# Holy Cross Catholic Primary School Early Learning Centre

2-14 Carlingford Road, Mickleham PA2403093

## Officer Assessment Report Development Approvals & Design

Figure 2 endorsed masterplan under permit P23005 (ELC circled)

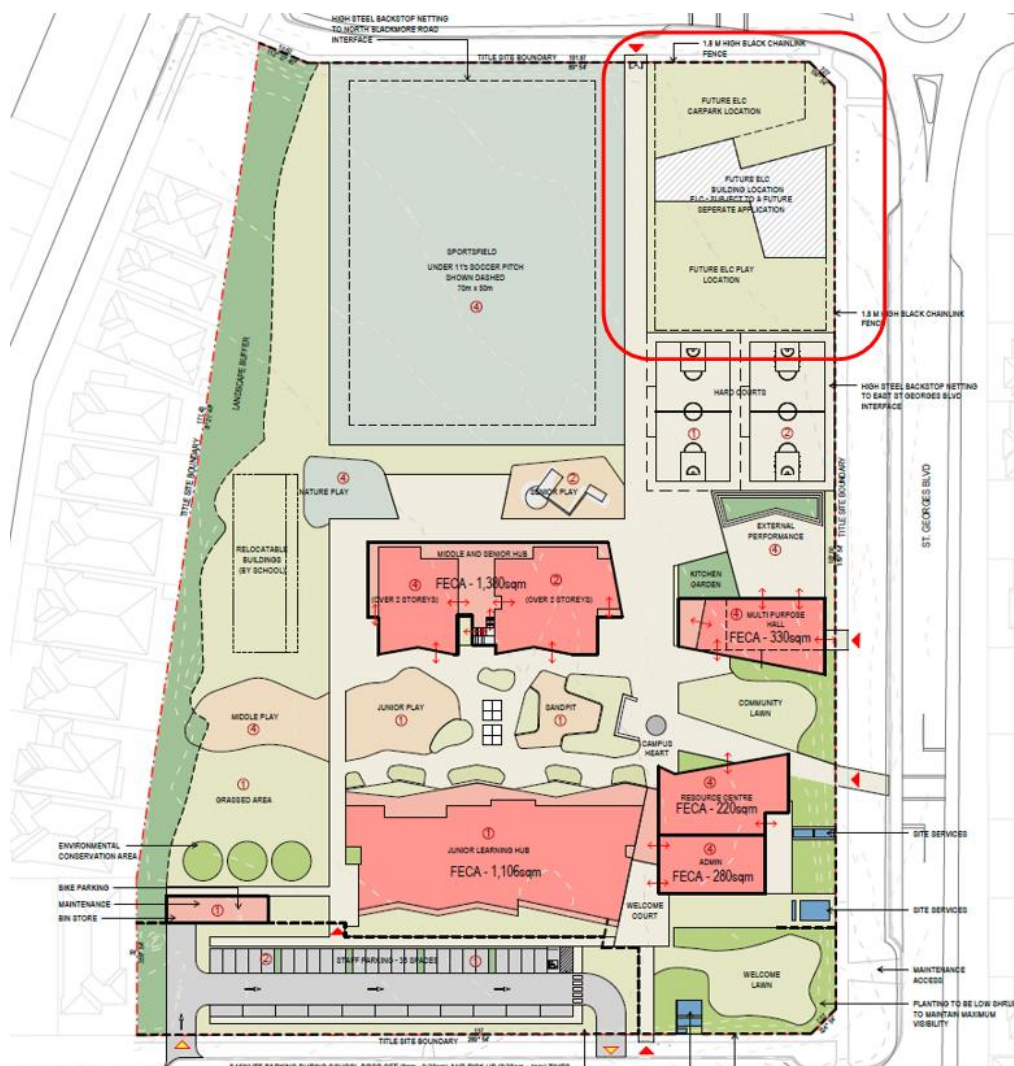
58. The endorsed masterplan shows a slightly different layout of the Children's Hub than proposed. Endorsed plans show an irregular shaped Children's Hub building that extends across the centre of northeastern corner, with limited setbacks to the east and west. Children's Hub car parking is shown north of the building with outdoor play areas to the south. The proposal reorientates the building footprint to deliver a greater setback from the northern boundary and outdoor play space to the west of the building.

59. The proposed Children's Hub provides a similar setback to the eastern boundary as shown on endorsed plans, however the building now extends south with a minimal setback to the existing hardstand basketball courts. The reorientation of the building enables a greater northern setback than shown in the endorsed masterplan.

60. While the layout of the Children's Hub slightly deviates from the layout shown on the endorsed masterplan, the proposal is generally consistent with the overarching vision of the masterplan.
